Preferred Project Report Lakes Estate Residential Subdivision

Project No 10034

Preferred Project Report

Lakes Estate Residential Subdivision

Figure 1 Preferred Project subdivision layout

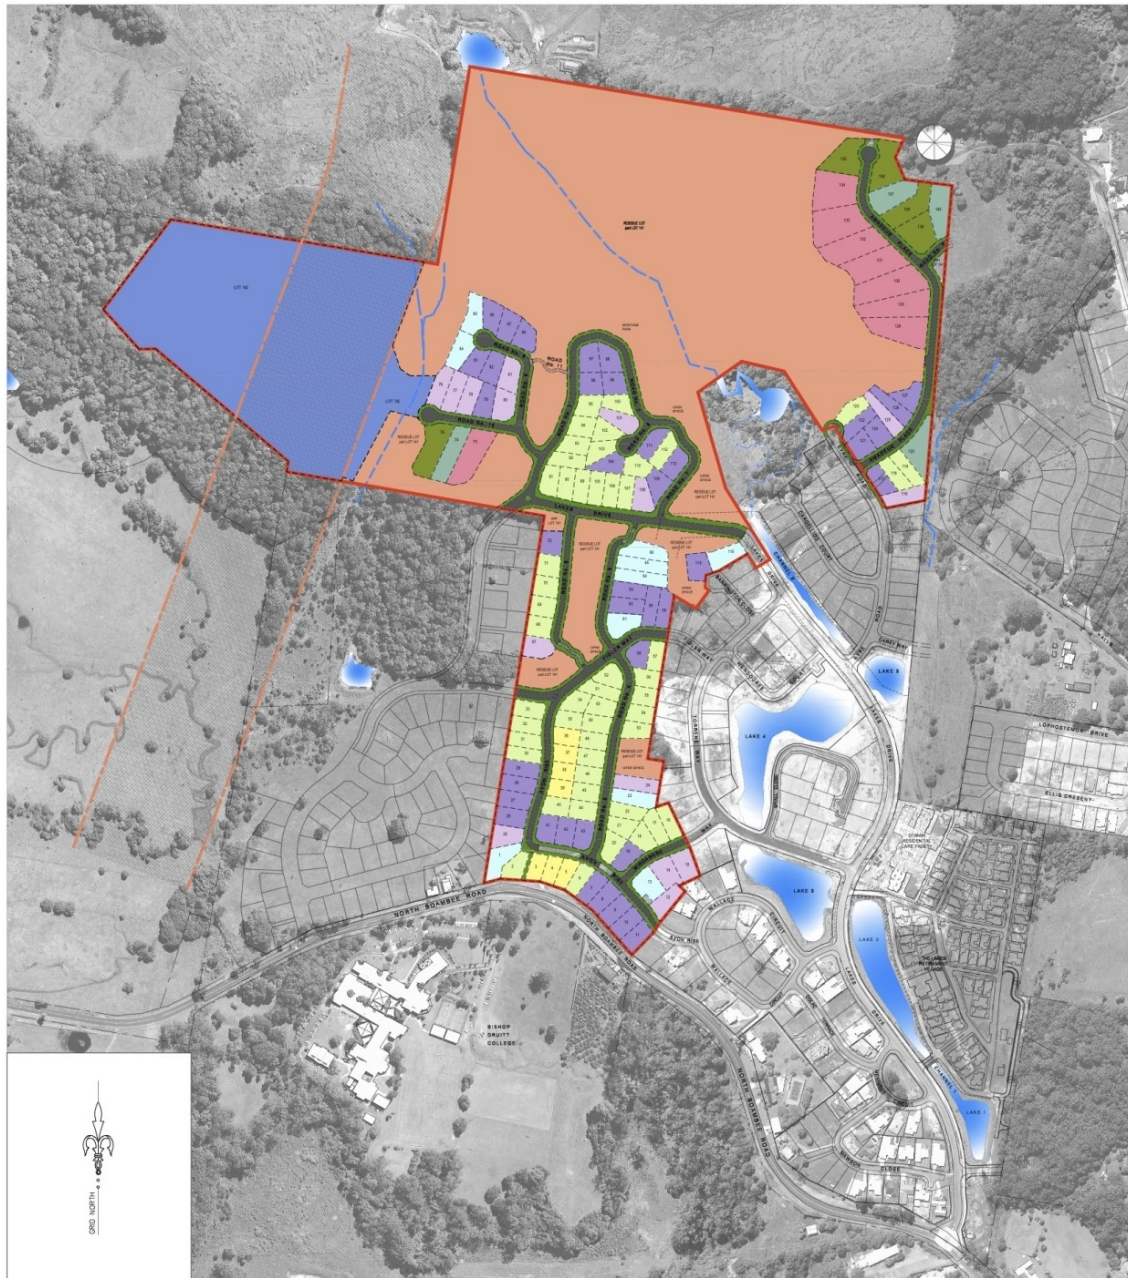
In response to the issues raised in the various submissions and as a result of subsequent design refinements, the Proponent has revised the subdivision layout for the proposal and this is illustrated in **Figure 1**.

- Reduction in total number of residential lots from 196 to 140;
- Removal of all residential development lots from land zoned 7A and providing open space in the central location along Lakes Drive between Stages 2 and 3;

Figure 4 Connections to Kratz Drive

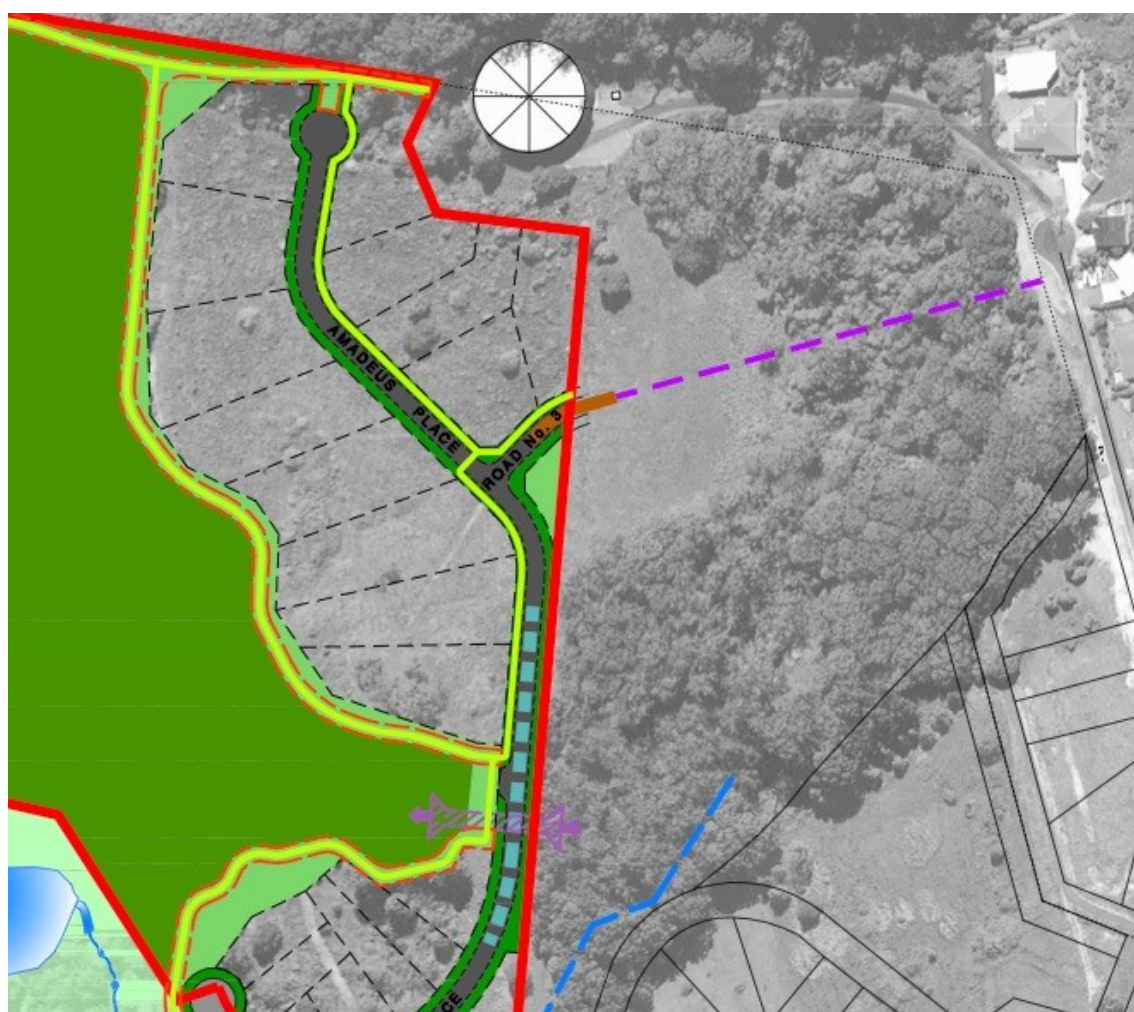
3.2.2 Issue: Connection to Kratz Drive Estate (north-east of site)

The connections to the north-east differ from those to Highlands Estate in that there are no current approvals for development to Kratz Drive. In assessing roads and movement in and around the subject site, “possible future road links” (purple dashed line) have been identified (refer 912-A008). An extract from that plan is included as **Figure 4**, showing also existing bushland and likely Asset Protection Zones.

The connection to a potential future Kratz Drive Estate has been provided in order to maximise the potential development in that area. Note also that the provision of a small area of open space in this location allows for some minor adjustments to the road location that could be made by the adjoining owner if necessary.

Figure 8 – Project Plan Application – Stage 3

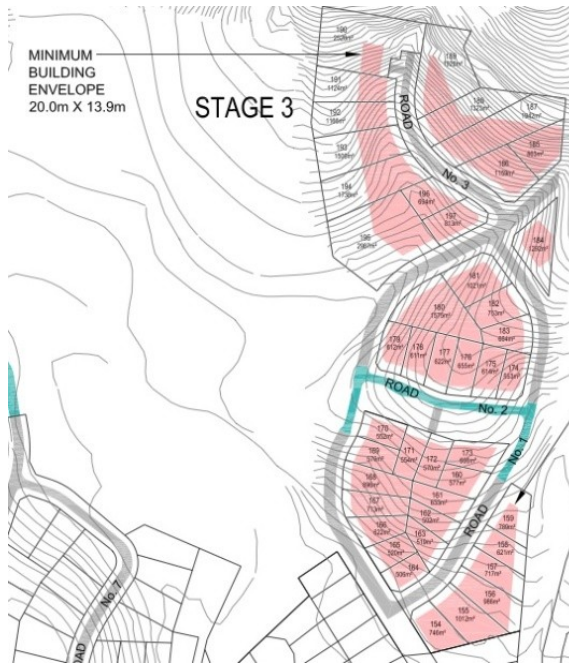
3.6.1 Issue: Revise Stage 3 to preserve koala habitat and corridor

“Consideration should be given to the deletion of Road No. 2; realignment of other proposed roads within Stage 3; and a revised lot layout created in this area to preserve all koala habitat and the existing habitat corridor.”

Stage 3 has been substantially redesigned both to retain koala habitat and better address the slope of the land. The road previously referred to as Road No. 2 has been removed and other roads have been realigned as requested.

Figure 8 illustrates the previous road pattern in this area, while **Figure 8a** illustrates the current subdivision layout, which more fully accommodates the koala habitat and corridors.
